TL-Series Trailing Arm Torque Specs

Correct Your Keyless Entry S/B

3.2TL TCS Indicator Light Troubleshooting

ACURA ServiceNews

'91-93 Legend Spoiler Installation

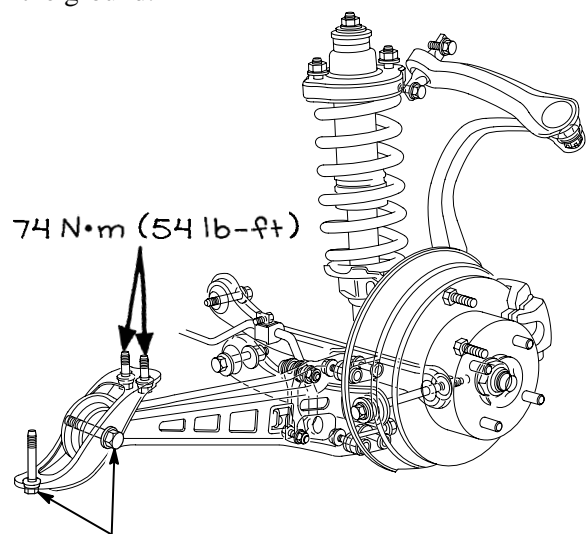
Nowadays, the only Legend spoilers we stock are designed for '94-95 models. These models did not require a brake light warning sensor and the accompanying wire harness.

You can still install these current spoilers on '91-93 Legends. In addition to the spoiler kit, however, you'll need to order a brake light warning sensor, P/N 37540-SM4-901, and a sensor harness, P/N 08F13-SP0-00009. Be sure to follow the appropriate installation instructions for the exact year and model Legend you're working on.

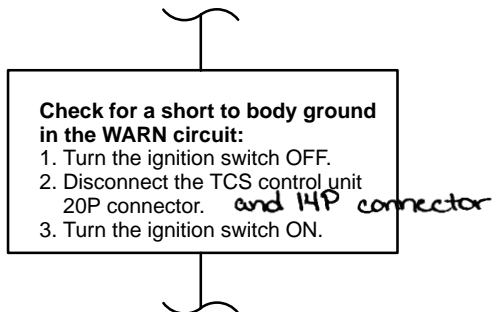
Service Bulletin 91-052, *Troubleshooting for the Optional Keyless Entry System*, for the NSX, Legend, and Vigor contains an error. (Or, since the same error is repeated on each input test, you might say it contains three errors.)

On each of the three input tests (pages 3, 4, and 5) locate the test for terminal 2, the GRN/RED wire. Because the GRN/RED wire carries the unlock signal to the control unit, change the condition to read, "Left door lock switch in *unlock* position." (The left door lock switch is checked in the lock position when you test the GRN/WHT wire.)

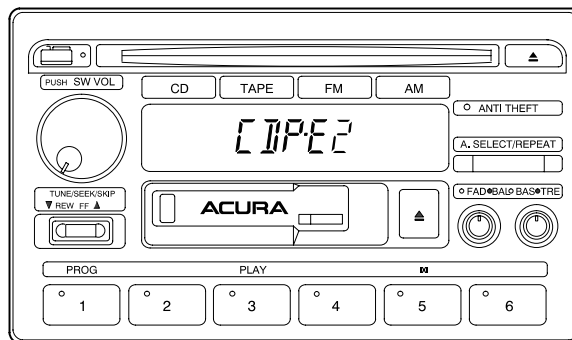
The TCS indicator light troubleshooting on page 19-88 of the '96 3.2TL S/M has a glitch in it. Make the following correction to all of your copies of the S/M.
